# TBT ENGINEERING CONSULTING GROUP

TBTE Ref No: 26-0120

Subject: City File Number: D02-02-24-0029  
**Update to Geotechnical Investigation**  
Concept Plan (April 2026)  
2095 Dilworth Road  
Ottawa, Ontario

Current Potential Concept Plan

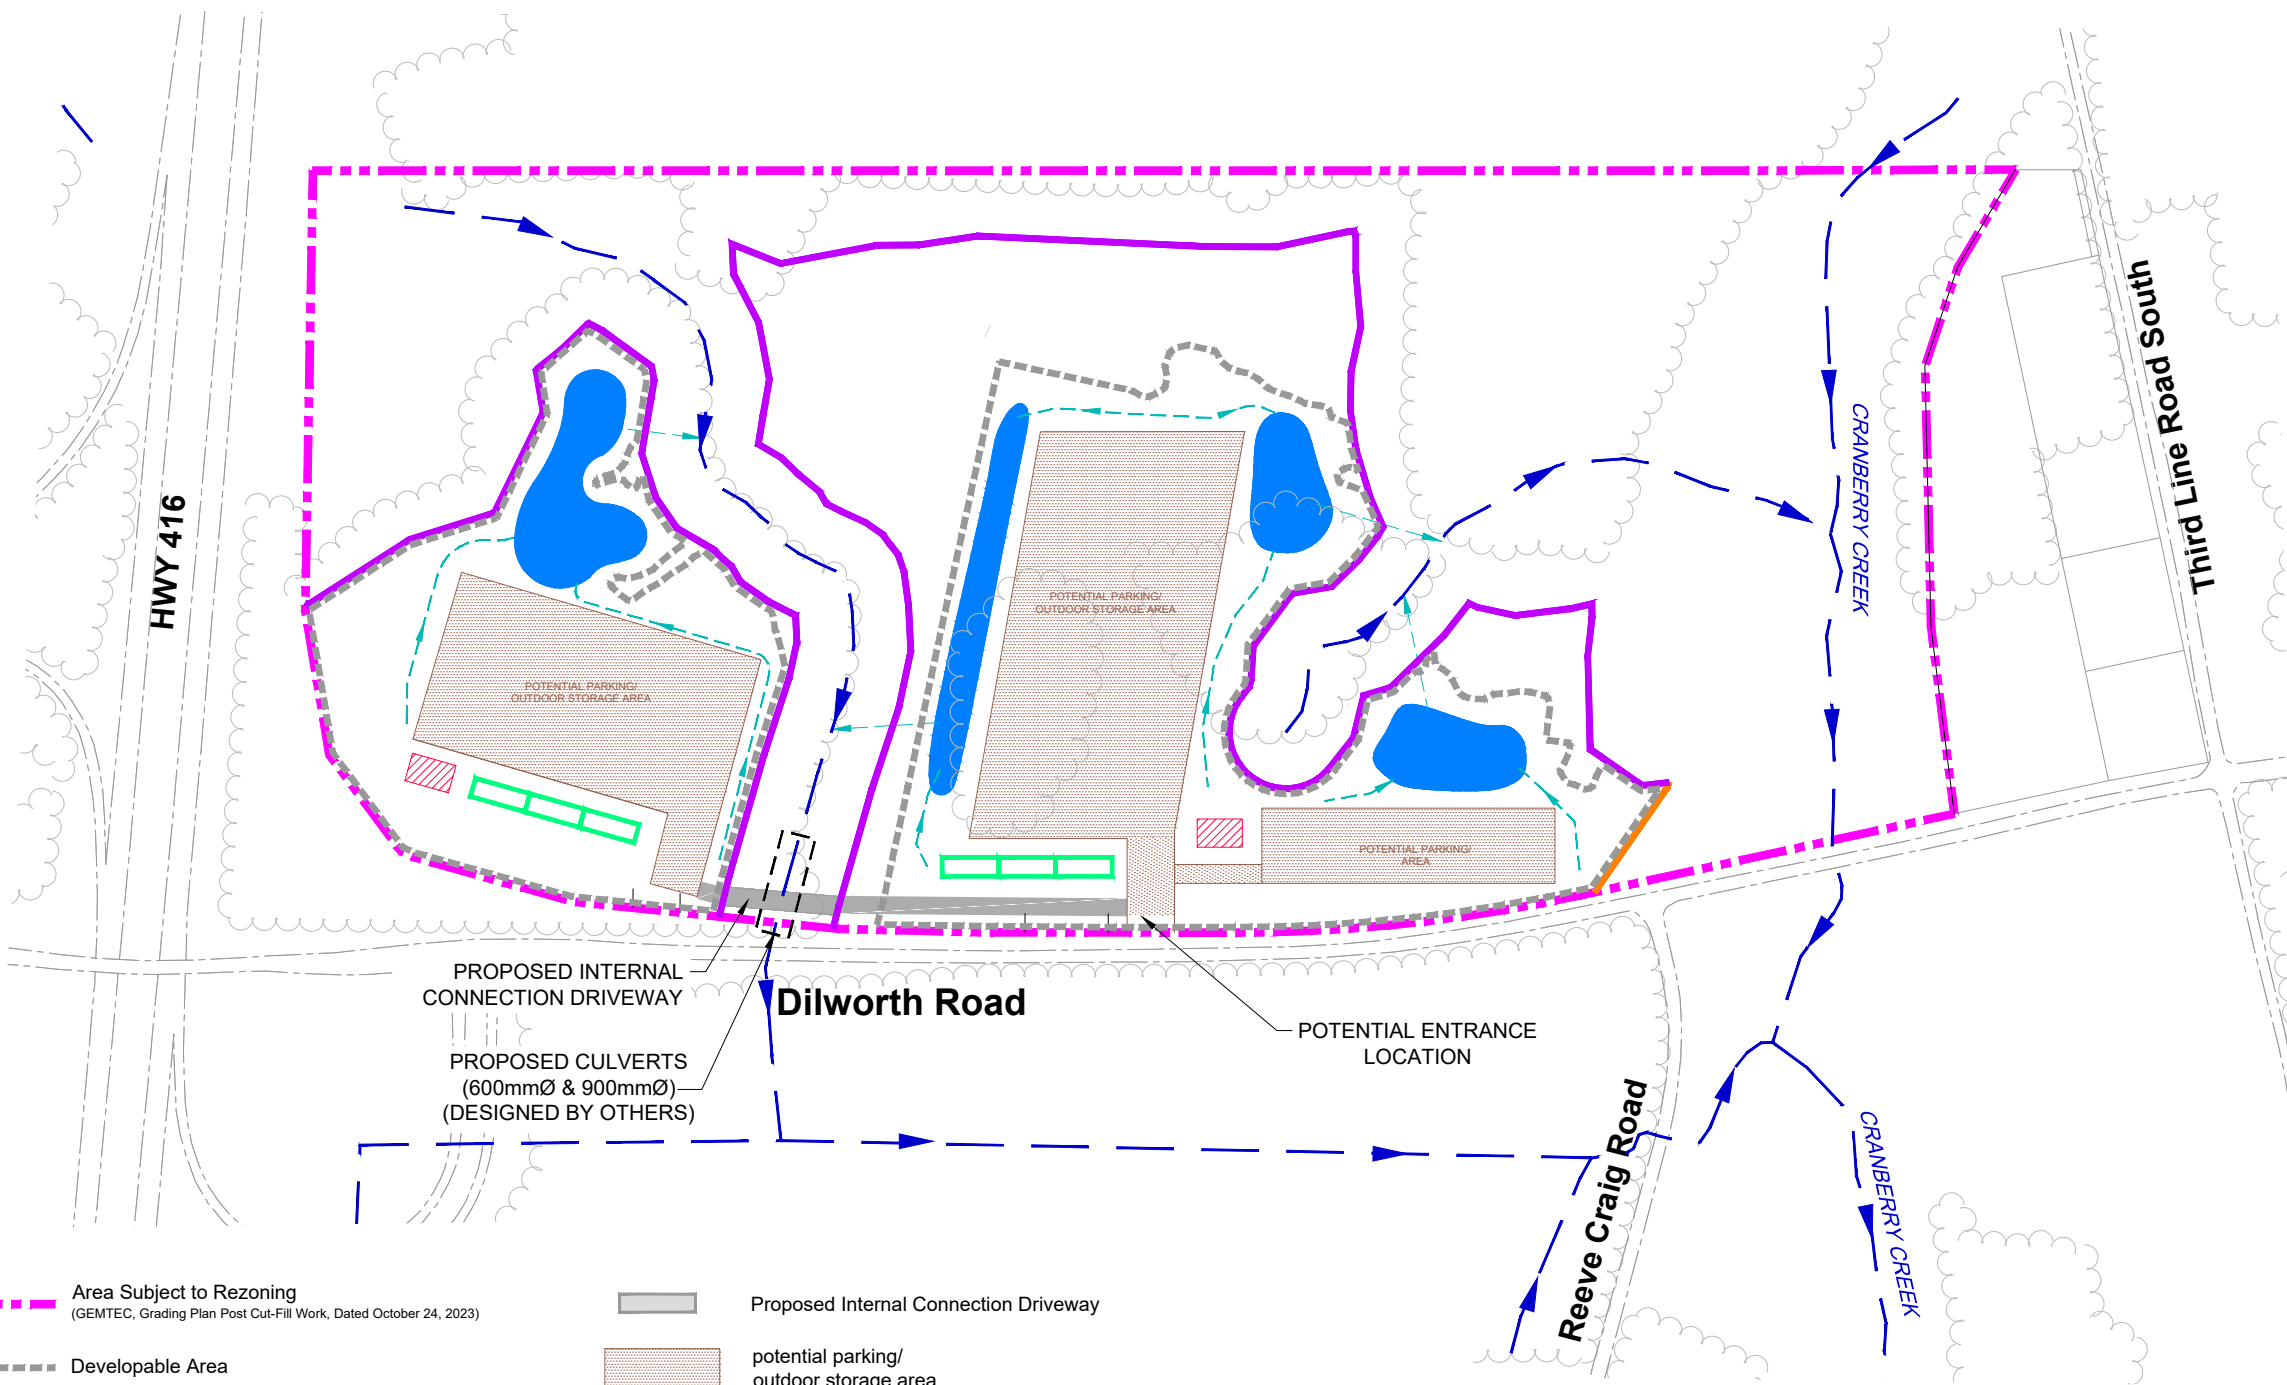
*Section 6.8 stated that permanent drainage with a frost-free outlet will be required. With Options 1 and 2 and consequently deep foundations, it is not clear how the gravity flow to an outlet will be achieved and if its feasibility was contemplated. It is not clear if the proposed foundation drainage will impact the surrounding area clays (excessive settlement) and what mitigation measures might need to be implemented. Please discuss and provide related recommendations in the report. If the use of sump pumps is anticipated, please include it in the discussion, also noting that the sump pumps will need to be equipped with a back-up system with an alarm and independent power supply, per Ottawa Sewer Design Guidelines, Second Edition, October 2012, with bulletins.*

The current potential concept plan has only two buildings, located along the south limit of the Site. The proposed buildings are located in the vicinity of MW21-06 and BH21-05. No unweathered clays were encountered in these locations.

The current potential concept plan has only two buildings, located along the south limit of the Site. The buildings are intended to be single-storey slab-on-grade structures with no basement level. Buildings with no basement levels and a floor slab set at least 0.3 m above the exterior grade generally do not require perimeter drainage.
